CITY PLANNING REPORT **REZONING & TEXT AMENDMENT** DOWNTOWN

10420 103 AVENUE NW

To allow for high rise mixed use development.

PROPOSED LOWER LEVELS OF SOUTH (103 Avenue) ELEVATION

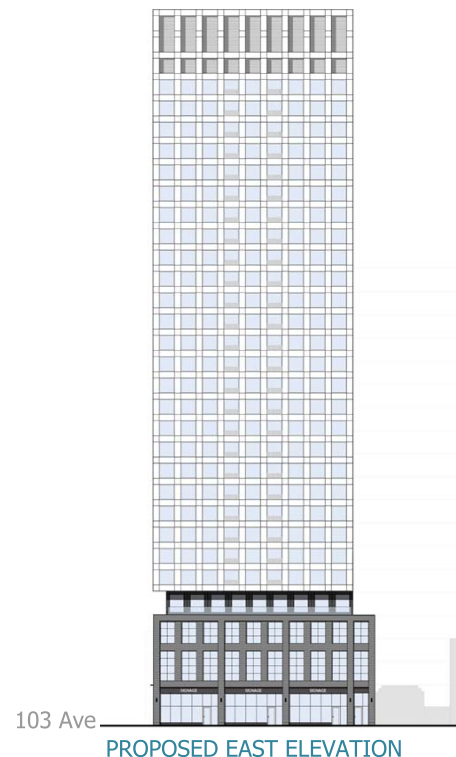
Active uses are provided for roughly two thirds of the south facing at-grade facade. Due to the site size constraints, a portion of the southern facade will not be glazed, but rather be solid wall, as the waste room is adjacent to 103 Avenue NW. This concern has been partially mitigated through the provision of public art along this portion of blank wall.

As proposed, the historically sensitive design elements wrap the corner for a portion of the 103 Avenue facade. This does not meet the expectation of historical podium and pedestrian oriented design along the full length of the building. The urban warehouse village character should not stop at the 104 Street frontage, but should be carried along the full frontage of 103 Avenue to integrate with the development within the Urban Warehouse Zone to the west, which has very similar character requirements with regards to podium/tower stepback design.

Although the brick design wraps partially onto 103 Avenue, it is not in the configuration of a podium with tower stepback above. As such, while there is a visual break at the fourth storey, the tower extends back to the property line from the fifth to the 28th storey, losing the improvement to the public realm that would be afforded from a podium design.

The western half of the south facade does not include any historic elements, podium or tower stepbacks. This portion of the tower is partially glazed and setback only 2.0 metres, with balconies

projecting back to the property line from the third to the 26th storey negating the benefits of the setback.

Together, the full length of the 103 Avenue facade does not meet the current policy of providing a 4.5 m stepback above a three to five storey podium, meaning that the tower directly abuts the pedestrian realm. The use of a podium would successfully address the two fundamental issues: the continuation of the scale and character of the warehouse area; and the separation of the mass of the tower from the public realm creating a comfortable pedestrian environment and mitigating some of the tower's negative effects (wind down washing and perceived massing).

Administration recognizes that a podium design may not be desired for every tower. There are other ways to mitigate the impact of a tower on the pedestrian realm. This can be accomplished through the provision of a greater tower setback or a large public plaza space. The proposed additional 1.4 metres of sidewalk width will help to improve the public realm along this interface. However, it is not considered sufficient to address the concerns of the missing podium and stepback on this facade which would push the tower back a minimum of 4.5 metres from the public realm.
